25240 - NAVAJO NATION PEACEMAKING BUILDING & AMPITHEATER

Addendum **ADD-1.0**

ADDENDUM 001

See attached revised drawings to address recent plan check comments and questions from bidders.

A1 FLOOR PLAN - CODE+LIFE SAFETY BLDG B

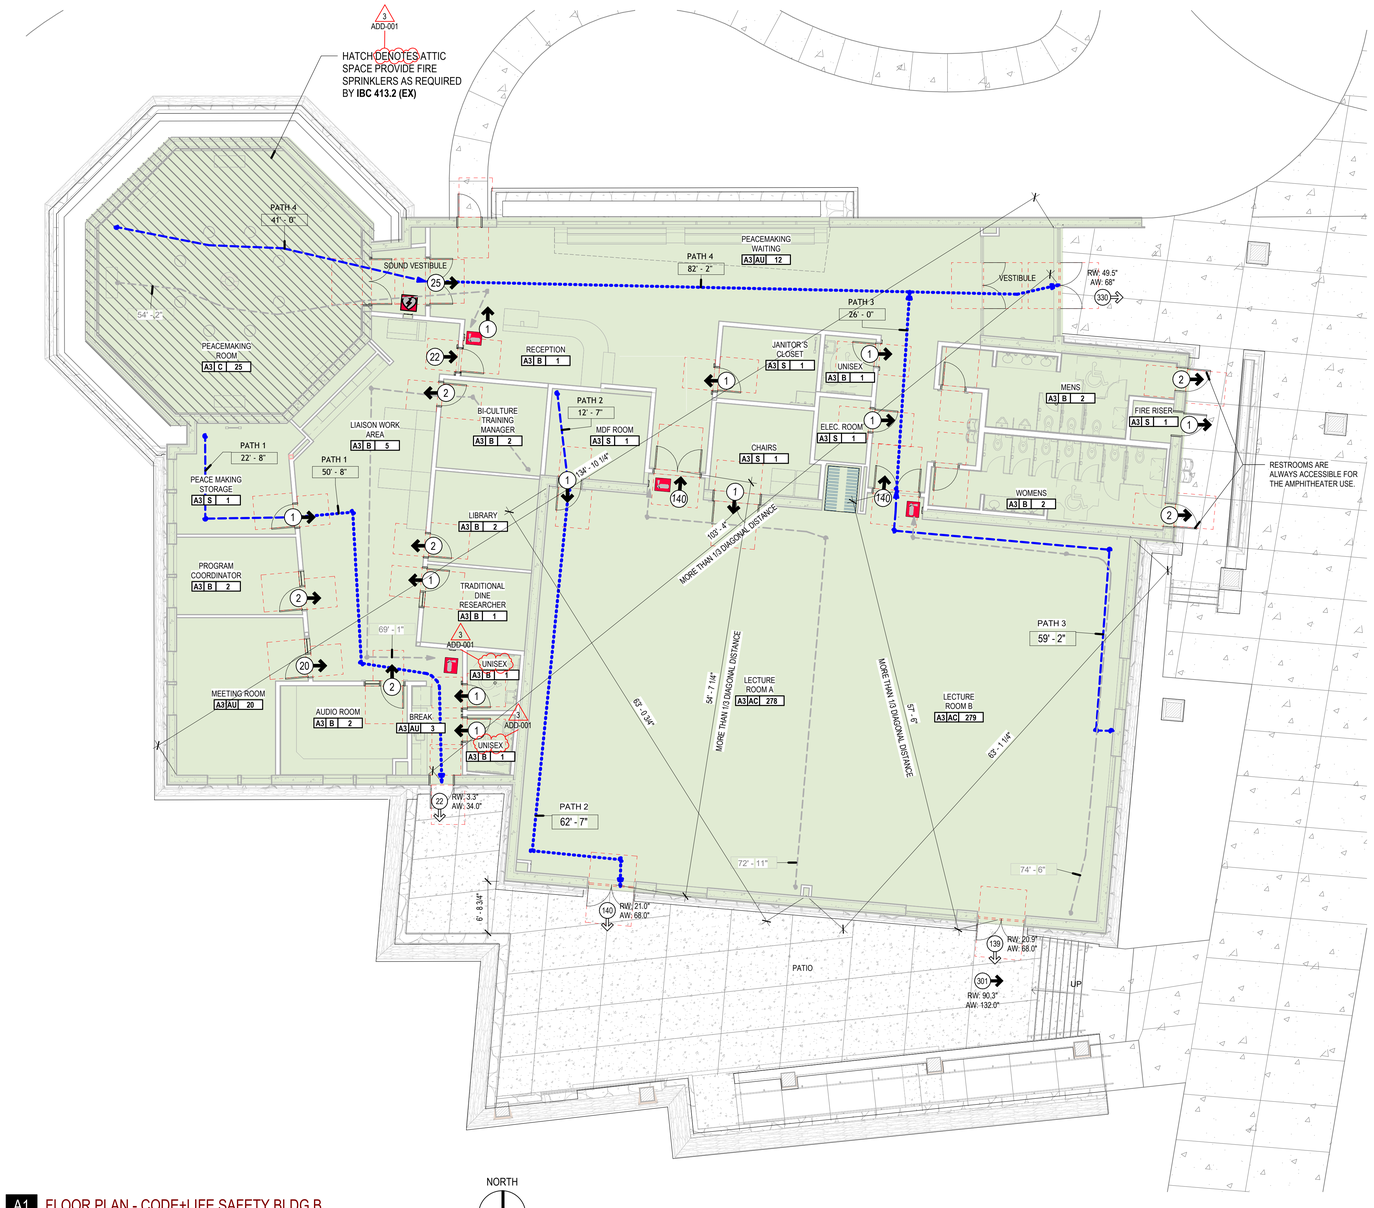
G101 *11/11/2026*	CODE + LIFE SAFETY - BUILDING B Relabeled restrooms to Unisex
AS100 *11/11/2026*	OVERALL SITE PLAN Added parking calculations
AS300.0 *11/11/2026*	AMPHITHEATER ANNOTATED PLAN Companion seat measurements added
A120.1 *11/11/2026*	ANNOTATED PLAN - BUILDING B Restrooms labels changed to Unisex, window tags changed. Added reference to Alternate #3 for fire pit removal
A120.2 *11/11/2026*	DIMENSION AND WALL TYPES - BUILDING B Restroom labels changed to Unisex
A120.3 *11/11/2026*	FINISH PLAN - BUILDING B Restroom labels changed to Unisex
A120.5 *11/11/2026*	FURNITURE PLAN - BUILDING B Restroom labels changed to Unisex, seating dimensions revised
A320.1 *11/11/2026*	BUILDING SECTIONS - BUILDING B Restroom labels changed to Unisex
A420.3 *11/11/2026*	ENLARGED PLANS + INT. ELEVATIONS - BUILDING B Restroom labels changed to Unisex

OVERALL UTILITY PLAN

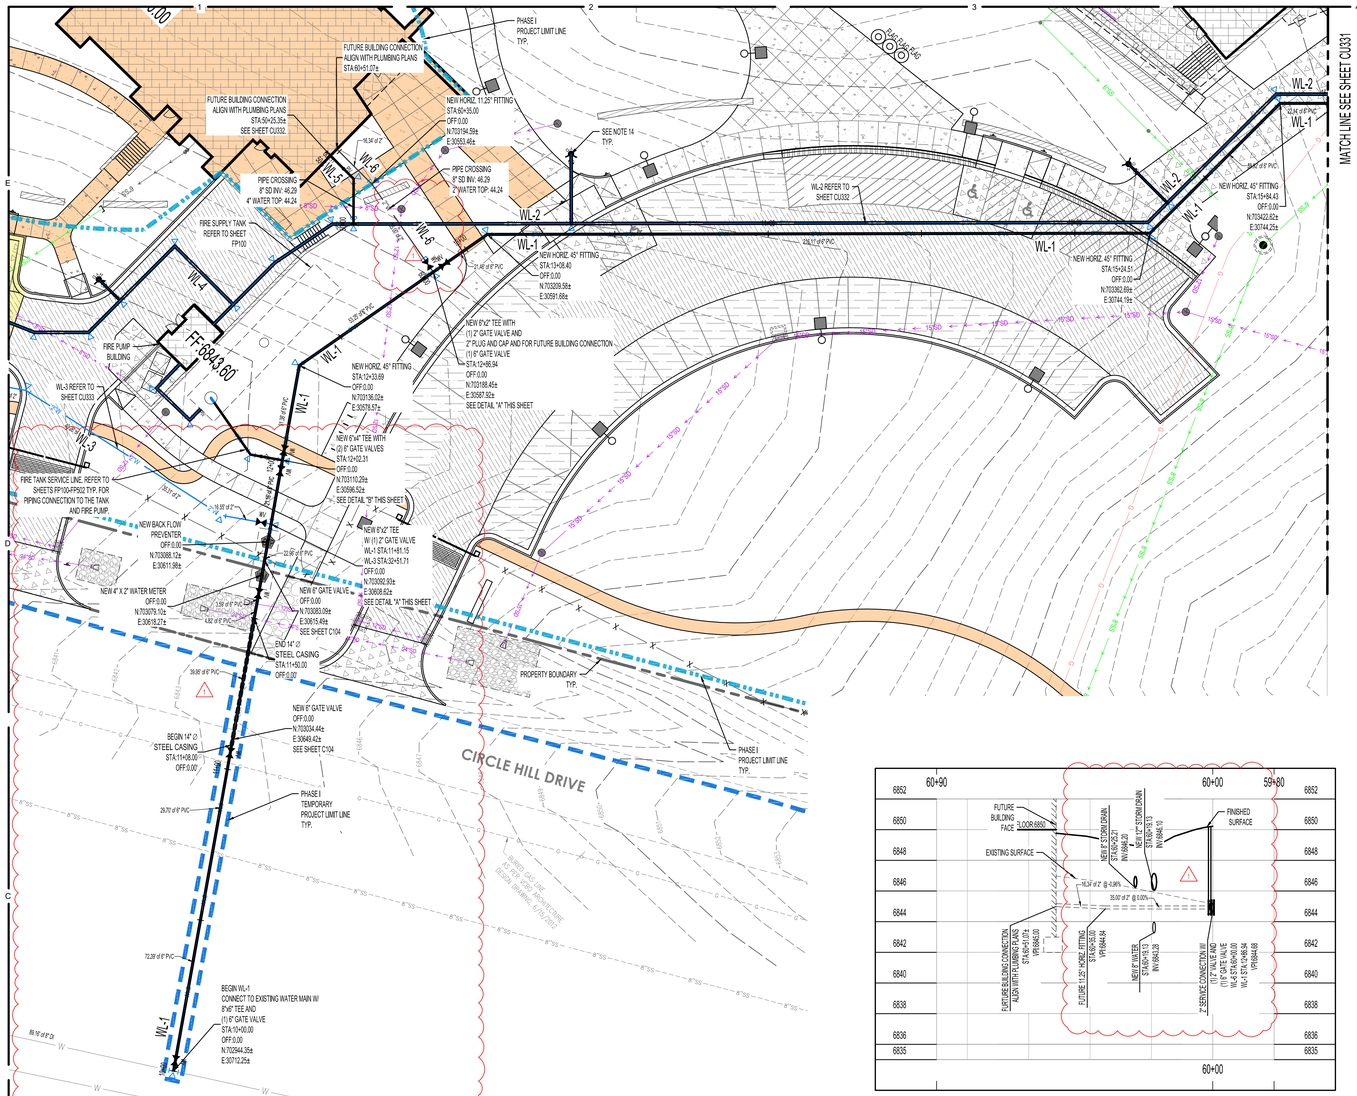
Sheet CU300– Refer to the Attached Sheet.
1- Updated callouts for water structures.

CU333

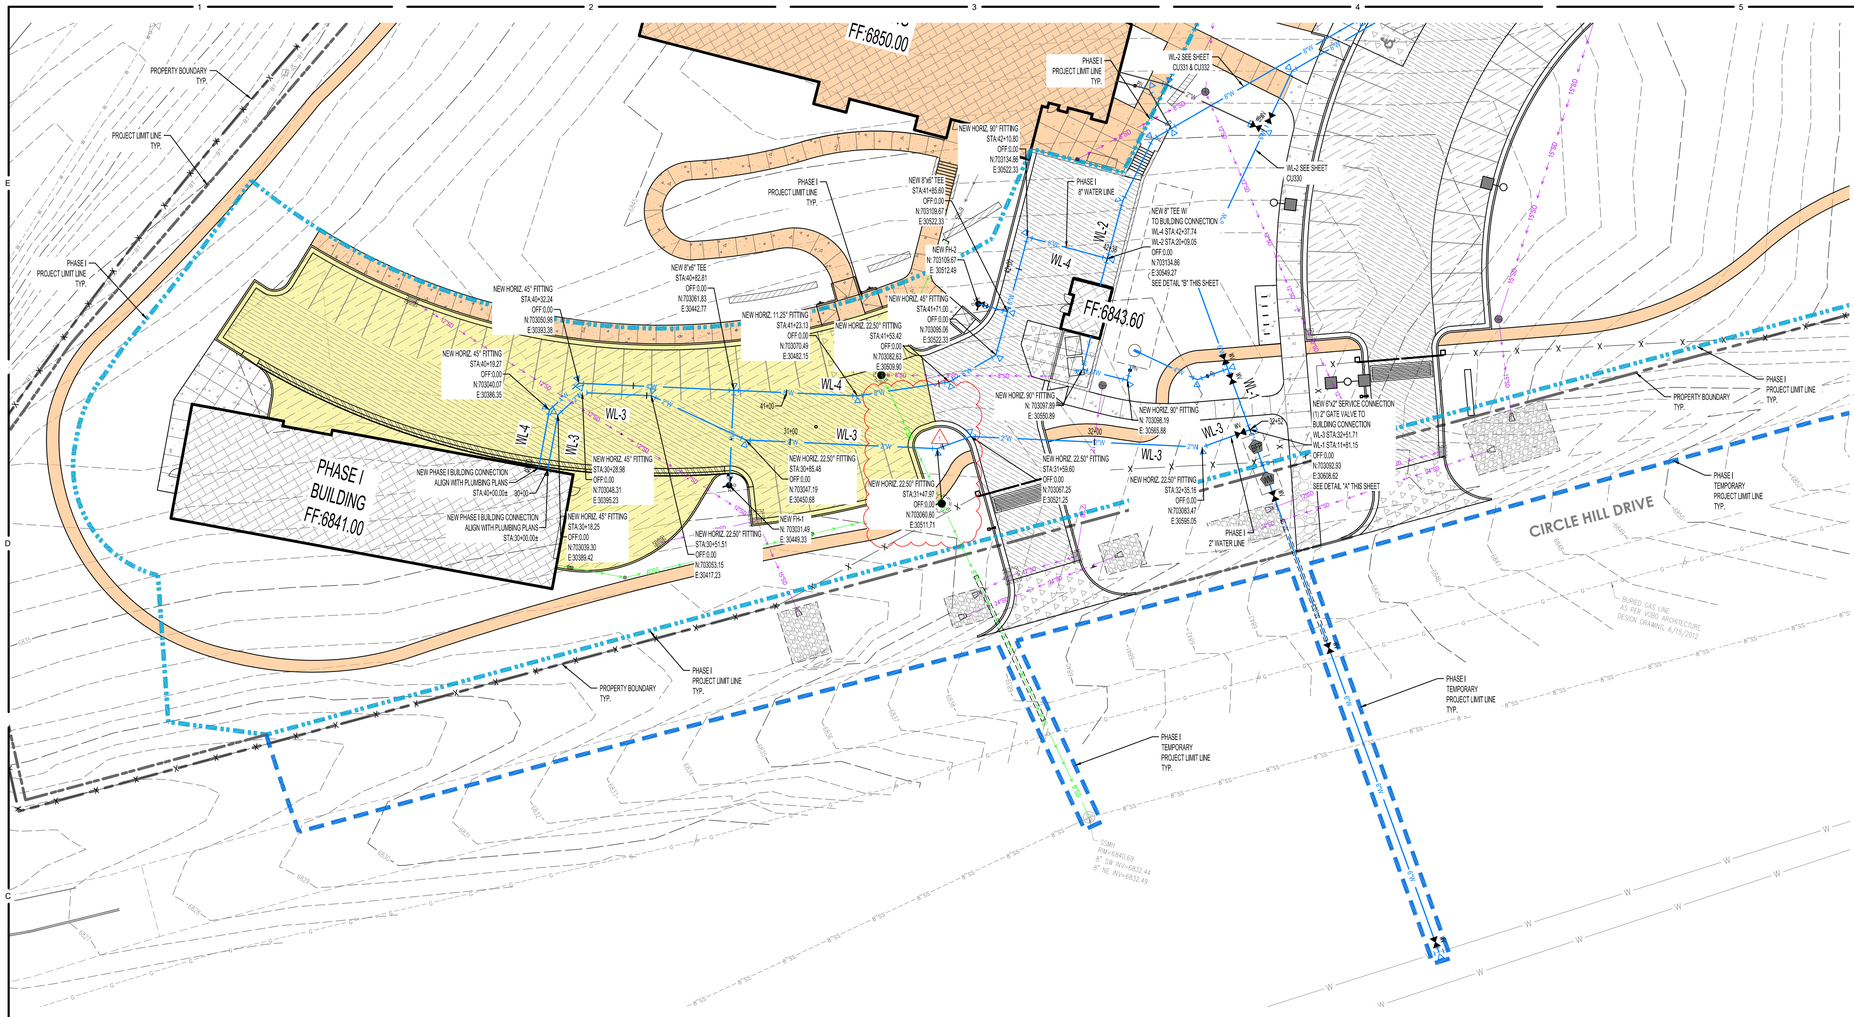
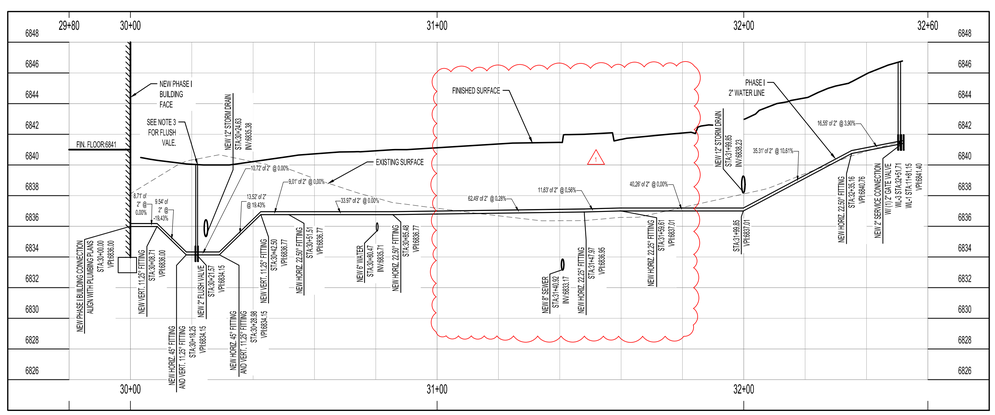
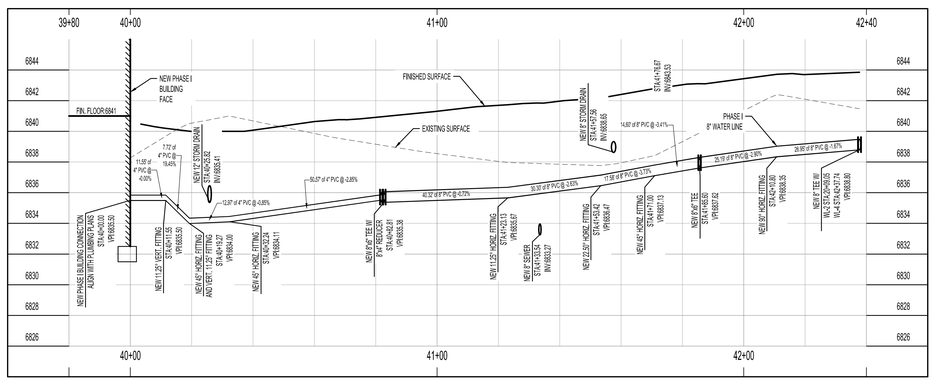
Sheet CU333– Refer to the Attached Sheet.
1- Removed 2" Water Meter.

A5 BUILDING B - LIGHTING PLAN
SCALE: 1/8" = 1'-0"

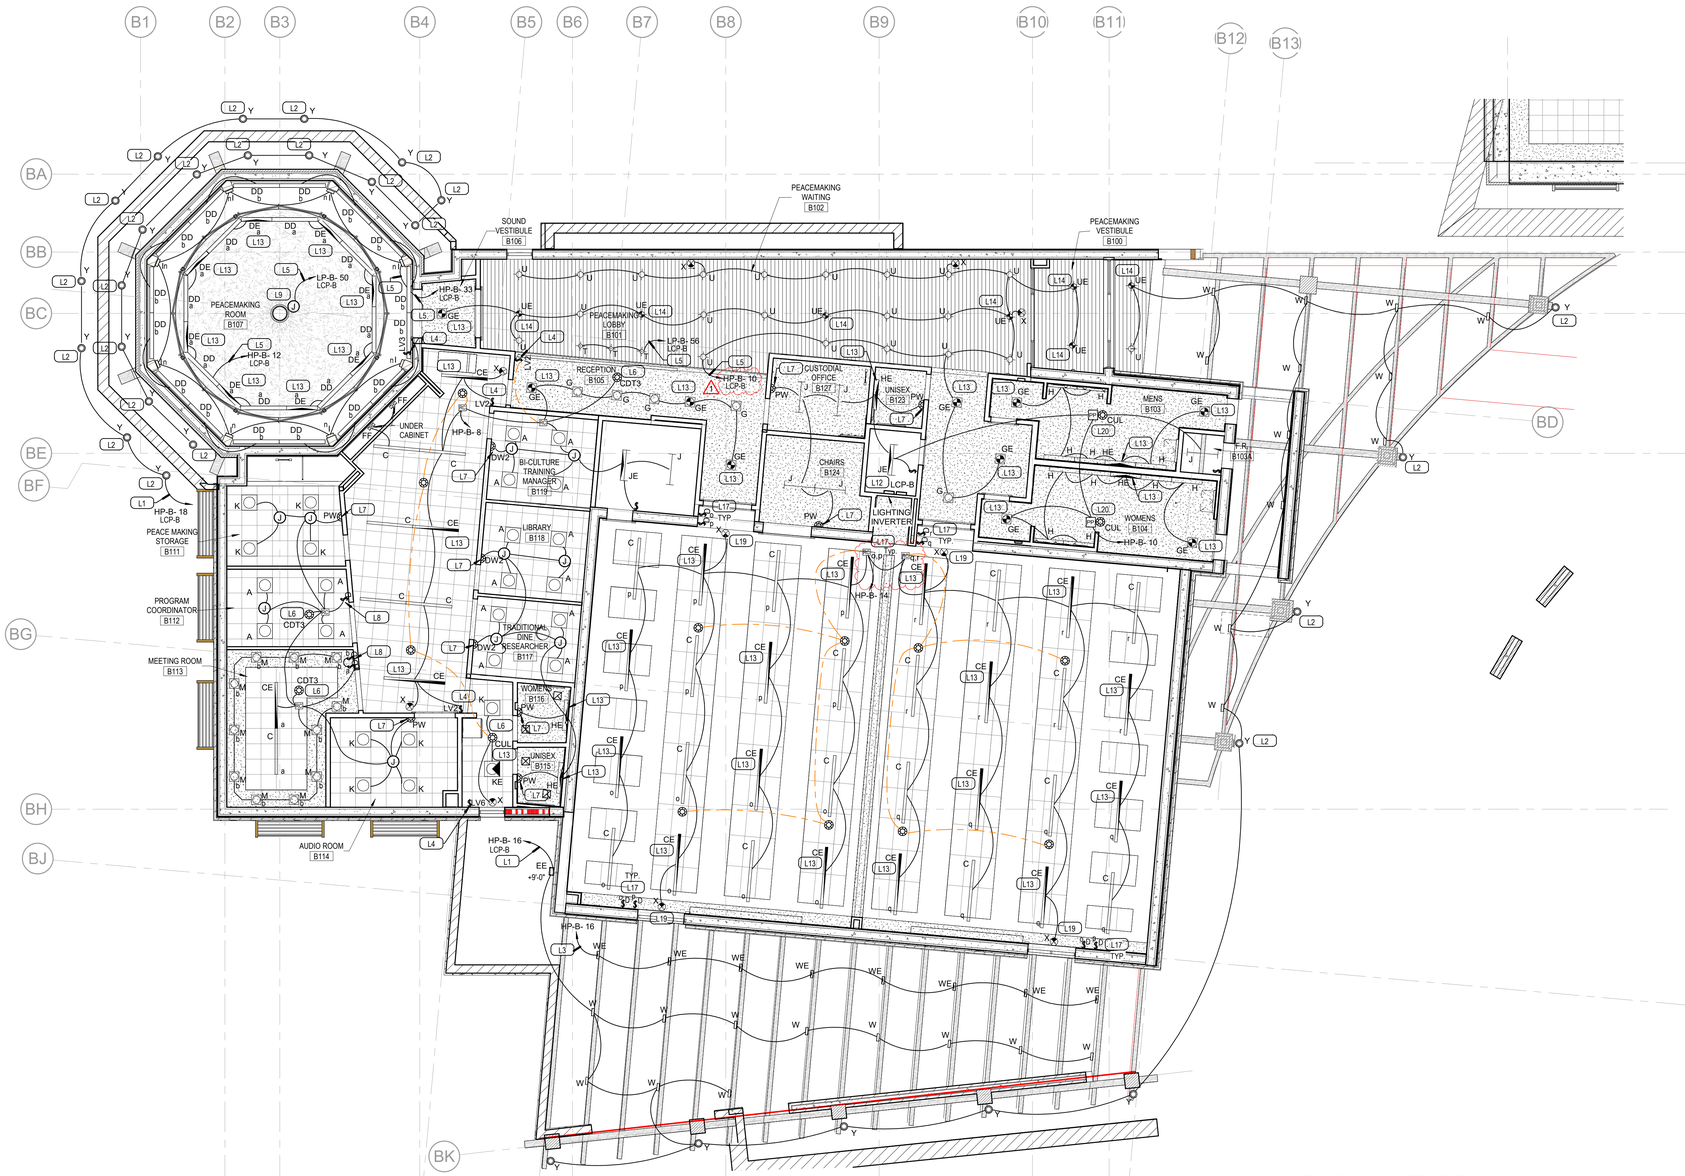
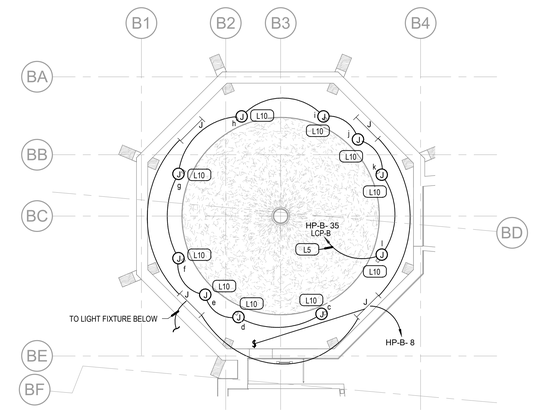
Sheet E120.3: Building B Lighting Plan

B1 ONE-LINE DIAGRAM

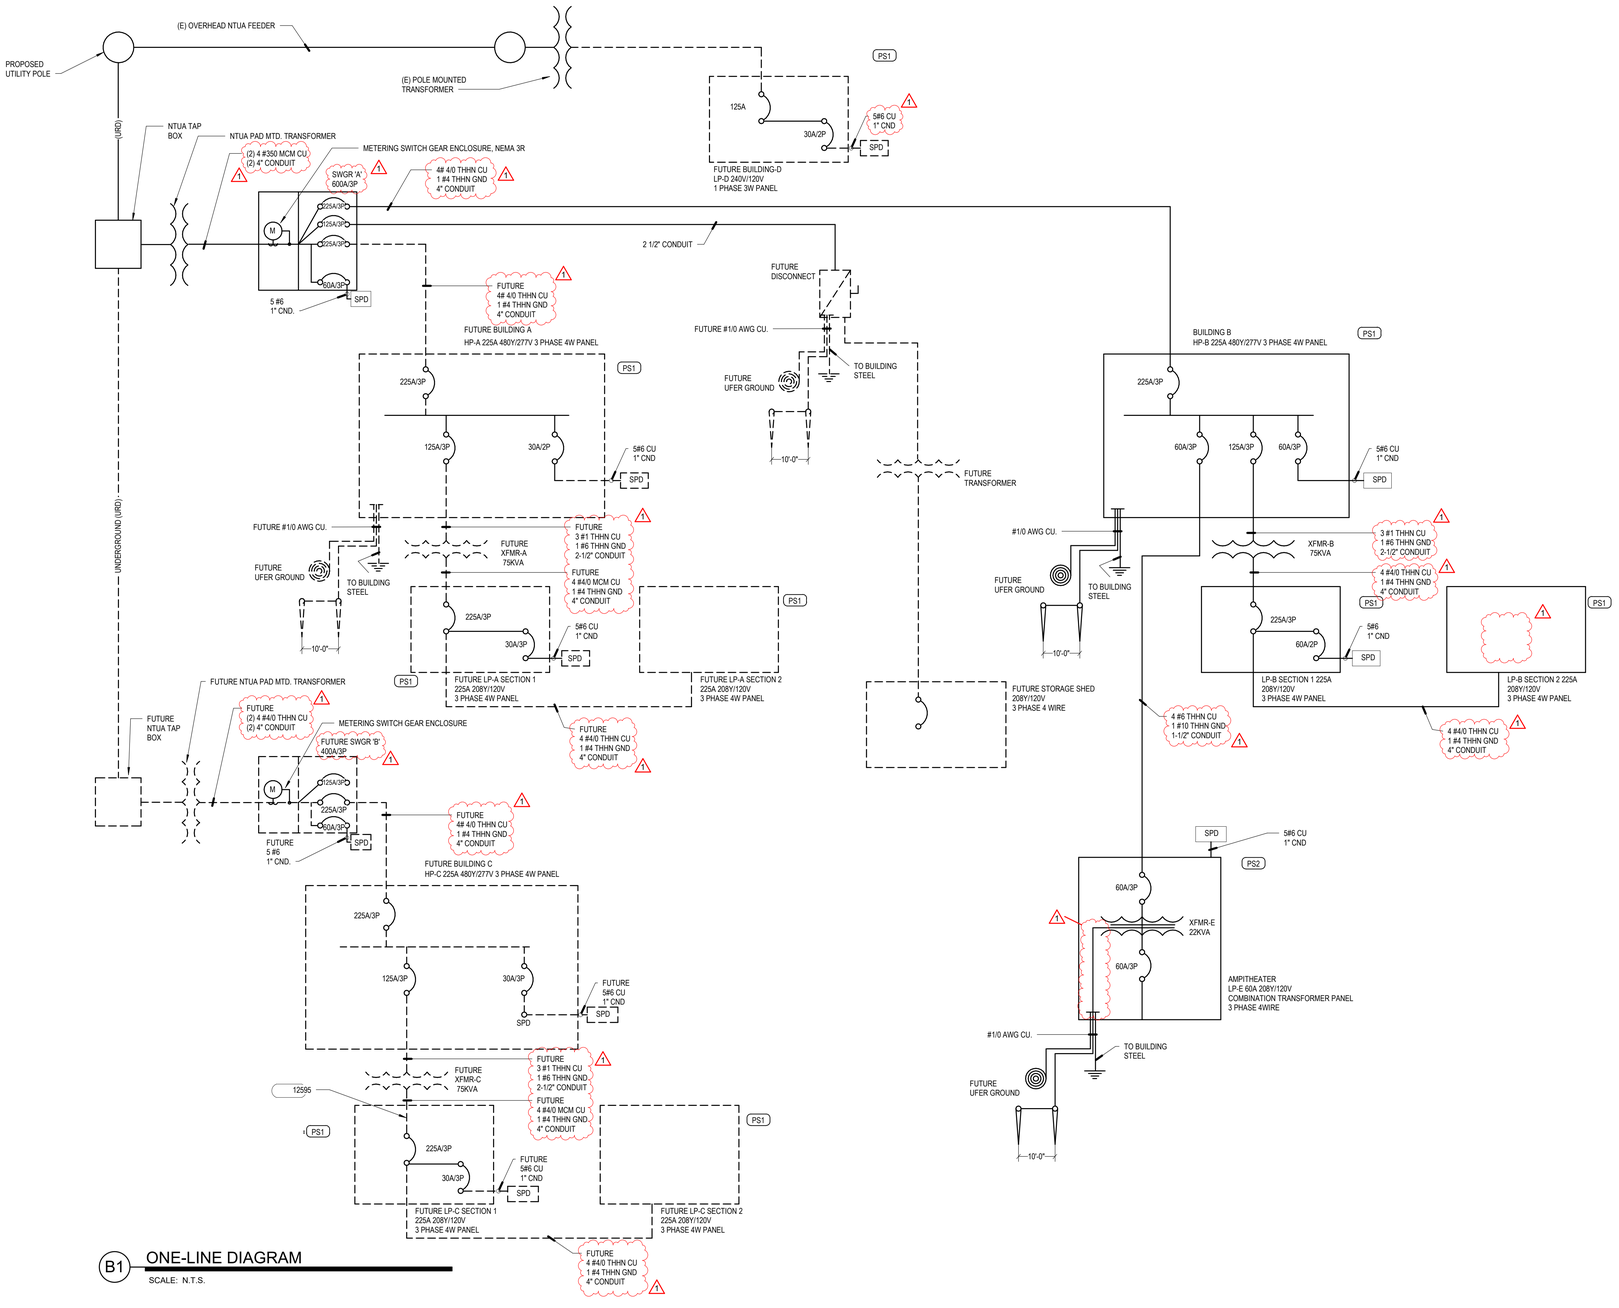
Sheet E600.1: One-Line Diagram

C2 BUILDING B GROUNDING DIAGRAM

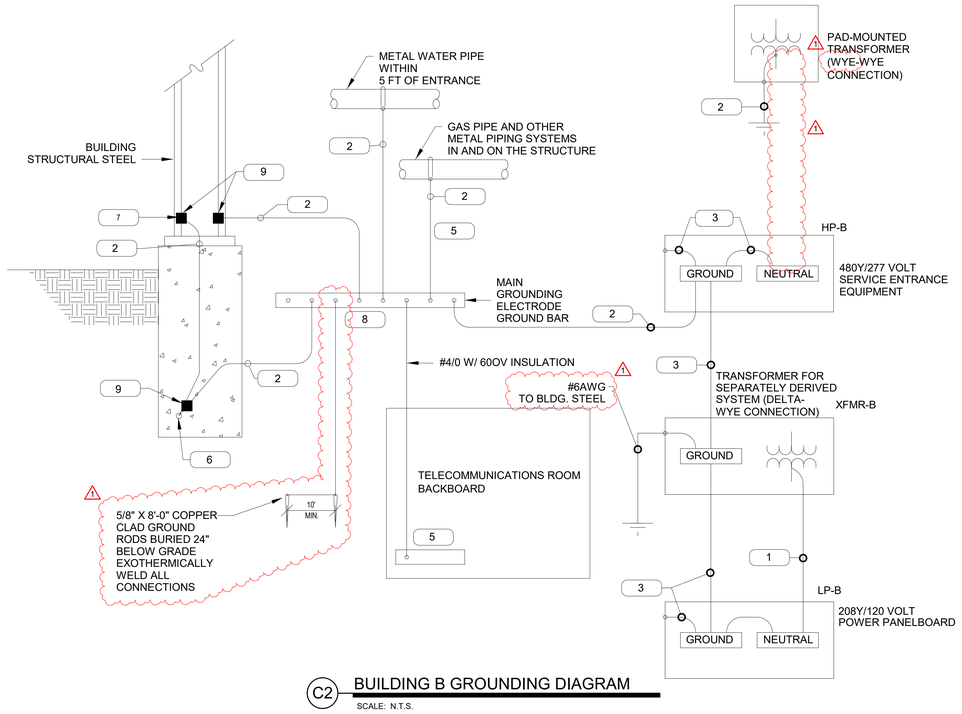
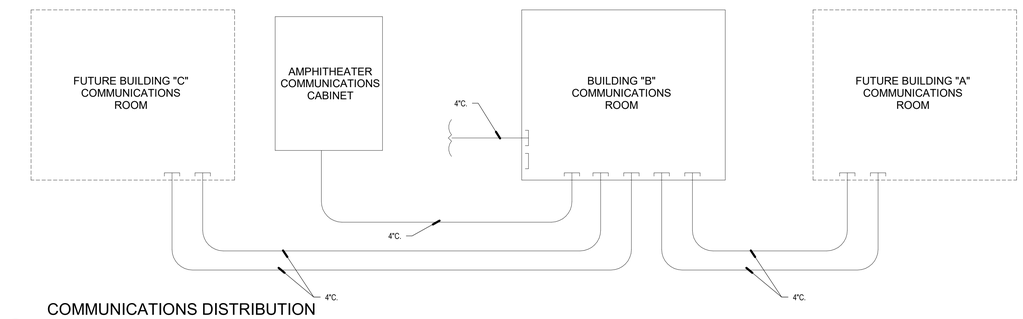
Sheet E600.2: Building B Grounding & Communications Distribution Riser Diagram
